## Product Change Notification / KSRA-15BCAH919

CCB 4437 Final Notice: Implement MMT shipping tube for selected AT27xxxx, AT28xxxx and SST39xxxx products available in 32L PLCC package.

**KSRA-15BCAH919  
CCB 4437**

## ❑ Tube Comparison (AT27xxxx and AT28xxxx Products):

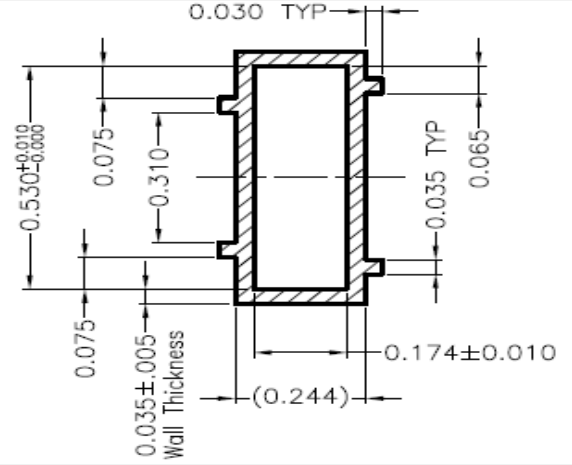
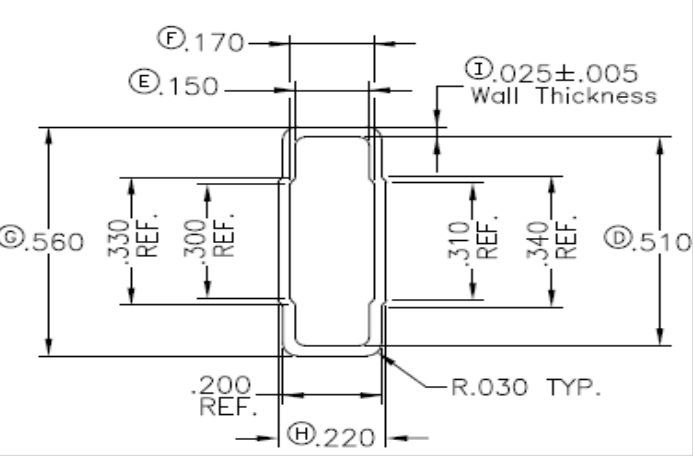
Pre change	Post change
<b>Tube Dimension</b>	
<p>Length: 20.40+/-0.10 inch            Width: 0.600+0.015/-0.005 inch            Tube Opening Length (A): 0.174 + 0.010 inch            Tube Opening Width (B): 0.530+0.010/-0.000 inch            Wall thickness (T): 0.035 + 0.005</p> <p><b>Tube Opening:</b></p> 	<p>Length: 21.70 ± 0.045 inch            Width: 0.560 ± 0.015 inch            Tube Opening Length (A): 0.170 ± 0.010 inch            Tube Opening Width (B): 0.510 ± 0.010 inch            Wall thickness (T): 0.025 ± 0.005 inch</p> <p><b>Tube Opening:</b></p>

## □ Tube Comparison (SST39xxxx products):

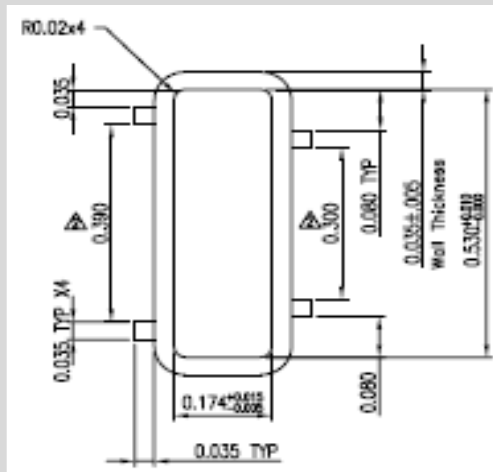
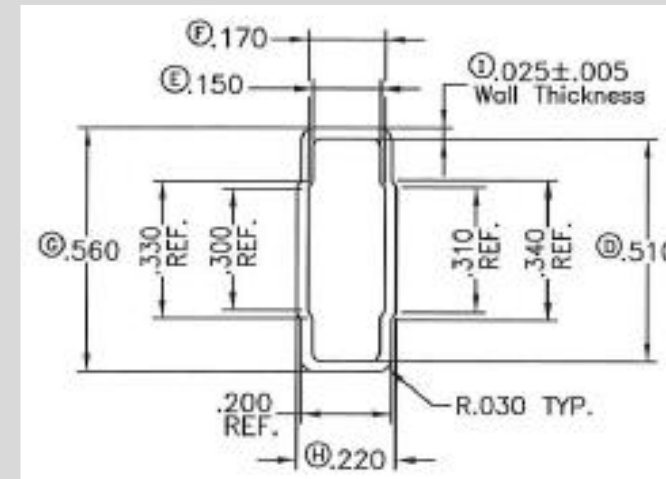
Length: 19.40+/-0.05 inch  
Width: 0.600+0.015/-0.005 inch  
Tube Opening Length (A): 0.174+0.010/-0.005 inch  
Tube Opening Width (B): 0.530+0.010/-0.000 inch  
Wall thickness (T): 0.035 ± 0.005

Length: 20.02 ± 0.05 inch  
Width: 0.560 ± 0.015 inch  
Tube Opening Length (A): 0.170 ± 0.010 inch  
Tube Opening Width (B): 0.510 ± 0.010 inch  
Wall thickness (T): 0.025 ± 0.005

## Tube Stopper

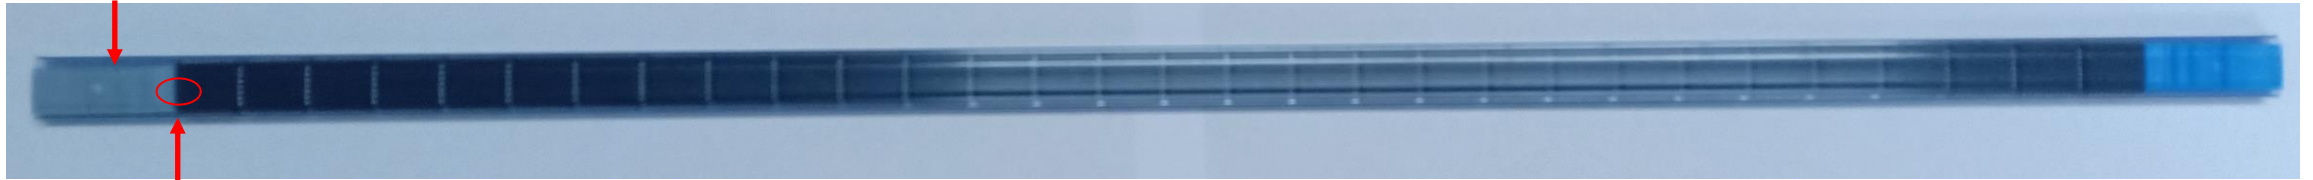
Blue and white colored stopper

Blue and gray colored stopper

## ❑ Tube Comparison (AT27xxxx and AT28xxxx Products):

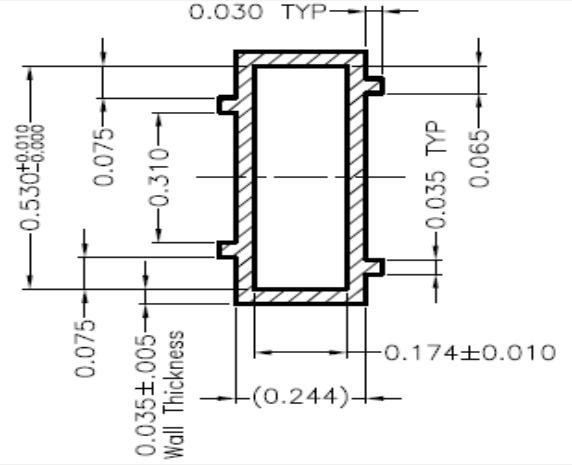
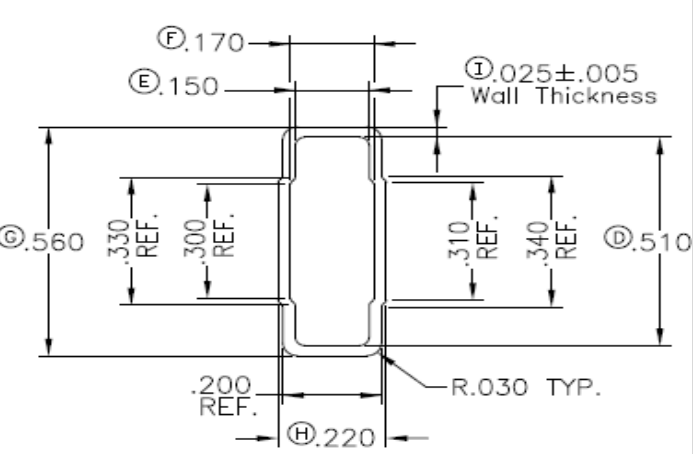
Pre change	Post change
<b>Tube Dimension</b>	
<p>Length: 20.40+/-0.10 inch            Width: 0.600+0.015/-0.005 inch            Tube Opening Length (A): 0.174 + 0.010 inch            Tube Opening Width (B): 0.530+0.010/-0.000 inch            Wall thickness (T): 0.035 + 0.005</p> <p><b>Tube Opening:</b></p> 	<p>Length: 21.70 ± 0.045 inch            Width: 0.560 ± 0.015 inch            Tube Opening Length (A): 0.170 ± 0.010 inch            Tube Opening Width (B): 0.510 ± 0.010 inch            Wall thickness (T): 0.025 ± 0.005 inch</p> <p><b>Tube Opening:</b></p>

## ☐ Tube Comparison (SST39xxxx products):

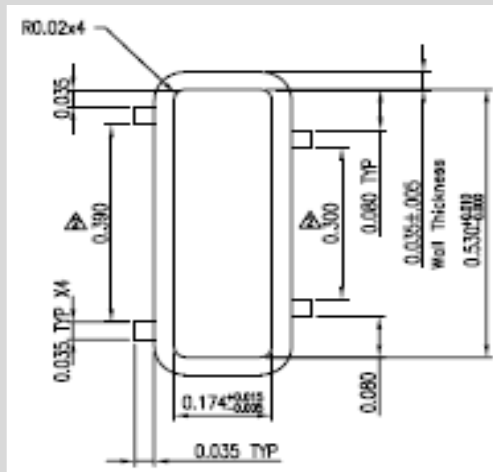
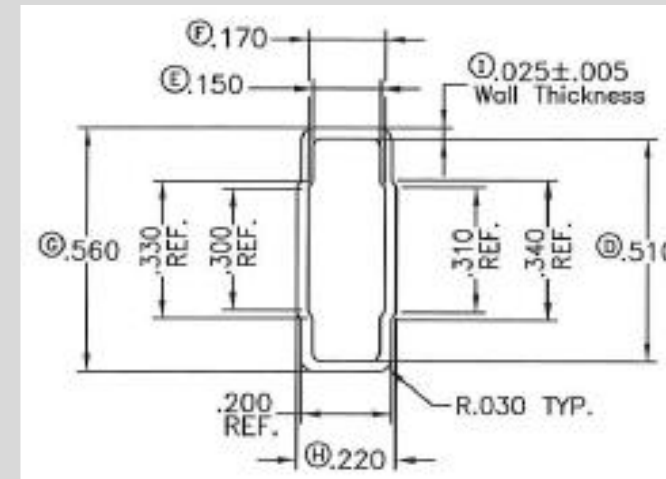
Length: 19.40+/-0.05 inch  
 Width: 0.600+0.015/-0.005 inch  
 Tube Opening Length (A): 0.174+0.010/-0.005 inch  
 Tube Opening Width (B): 0.530+0.010/-0.000 inch  
 Wall thickness (T): 0.035 ± 0.005

Length: 20.02 ± 0.05 inch  
 Width: 0.560 ± 0.015 inch  
 Tube Opening Length (A): 0.170 ± 0.010 inch  
 Tube Opening Width (B): 0.510 ± 0.010 inch  
 Wall thickness (T): 0.025 ± 0.005 inch

## Tube Stopper

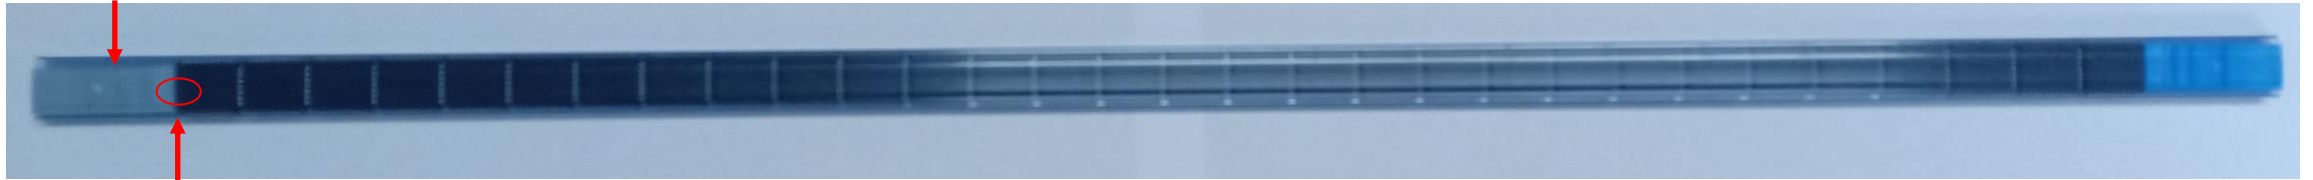
Blue and white colored stopper

Blue and gray colored stopper
